DATE ~~R~~ Aug. 7/03**V2500-A1/A5 NACELLE SERVICE BULLETIN**

This document transmits Revision 5 to Service Bulletin NV2500-29-0263 and
 Revision 5 to the Supplement

V2500-NAC-29-0263

NACELLE – HYDRAULIC POWER – LOW PRESSURE (LP) HYDRAULIC SWITCH – INSTALLATION OF NEW FLEXIBLE HOSE ASSEMBLY AND SUPPORT BRACKET

Installation of the new Flexible Hose Assembly and Support Bracket
Figure 1, Sheet 1 of 2

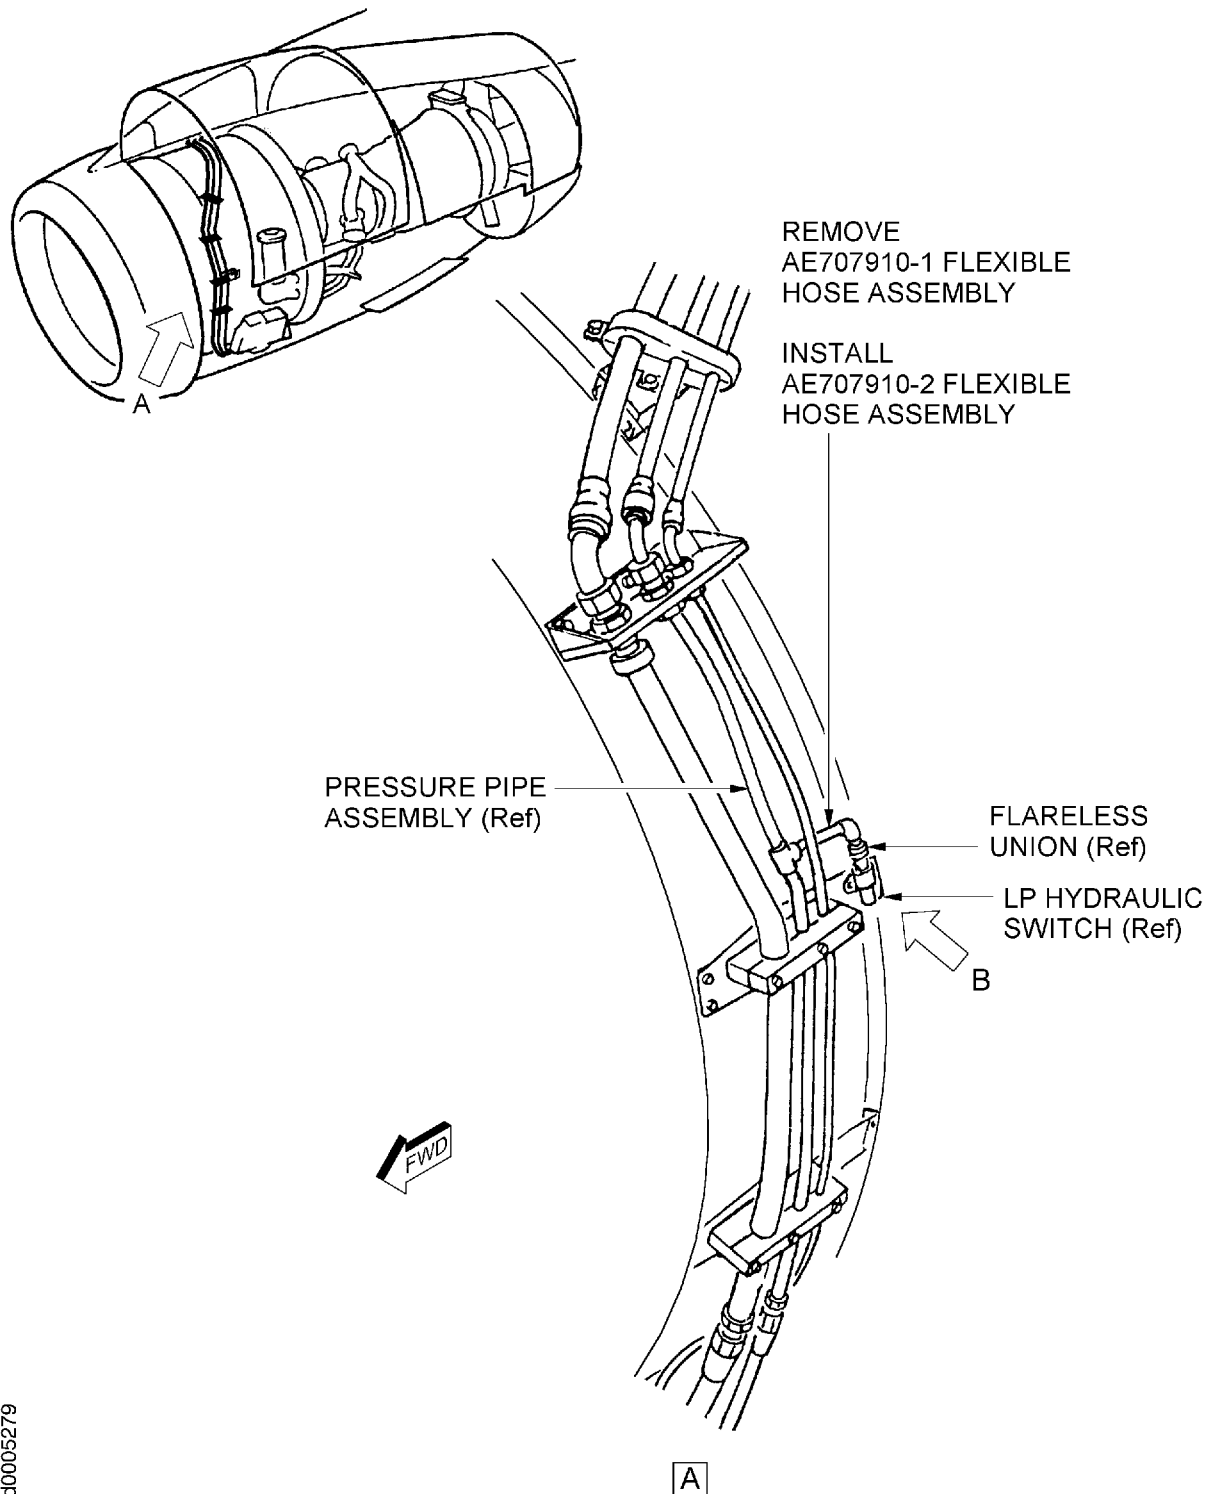
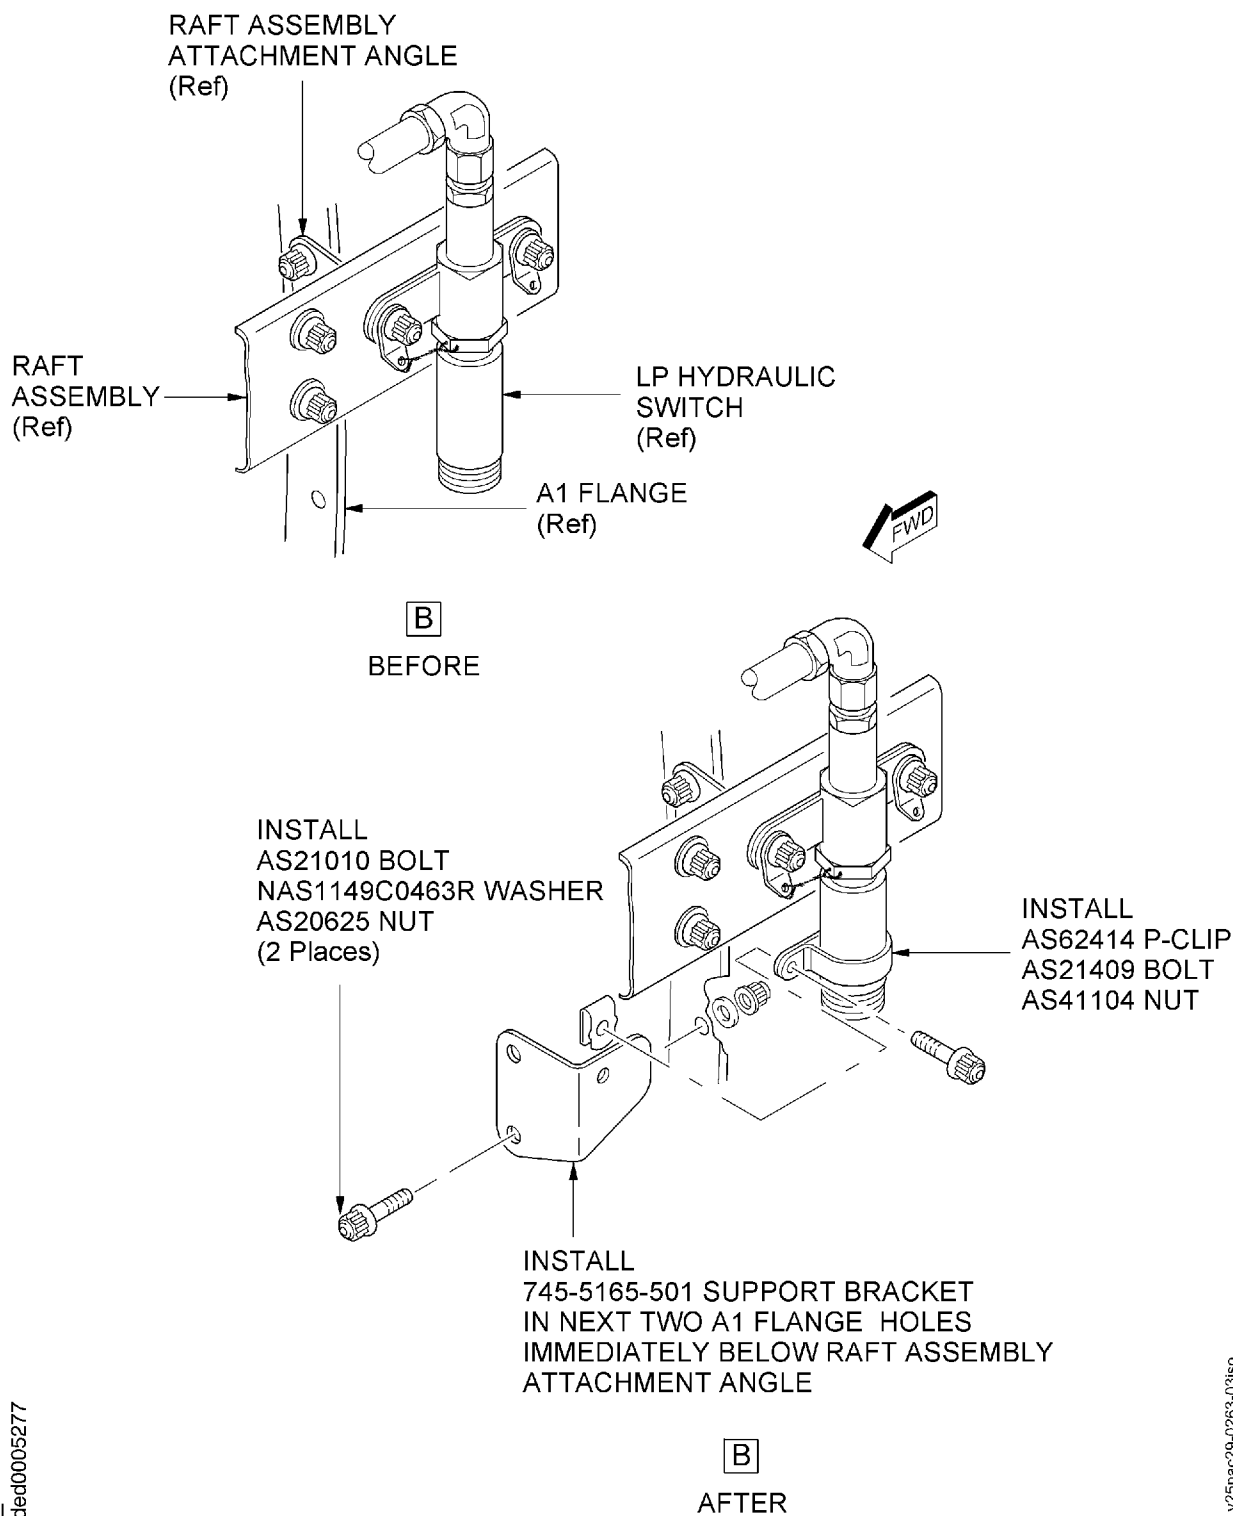
- (a) The Flexible Hose Assembly fitted from the Pressure Pipe Assembly to the LP Hydraulic Switch is removed and replaced with a new Flexible Hose Assembly.
- (b) A new Support Bracket is installed to the A1 Flange immediately below the Raft Assembly.
- (c) The new P-Clip is fitted to the LP Hydraulic Switch and secured to the new Support Bracket with the new Bolt and Nut.

- (1) Put a clean container in position below the AE707910-1 Flexible Hose Assembly. Refer to Figure 1, view A.

- (8) Use a clean, lint free cloth dampened with CoMat 01-076 Solvent to remove all oil, grease, dirt or other contaminants from the surface of the A1 Flange where the new 745-5165-501 Support Bracket is to be installed. Wipe the area dry with a clean, lint free cloth before the CoMat 01-076 evaporates. Refer to Figure 1, view B.

- (6) Torque the AE707910-2 Flexible Hose Assembly end fitting at the Pipe Assembly to 135 - 145 lbf.in (15,3 - 16,4 Nm) as instructed in the SPP-V2500-1IA Standard Practices/Processes Manual, Chapter 70-41-00.

- (7) Torque the AE707910-2 Flexible Hose Assembly end fitting at the Flareless Union to 135 - 145 lbf.in (15,3 - 16,4 Nm) as instructed in the SPP-V2500-1IA Standard Practices/Processes Manual, Chapter 70-41-00.
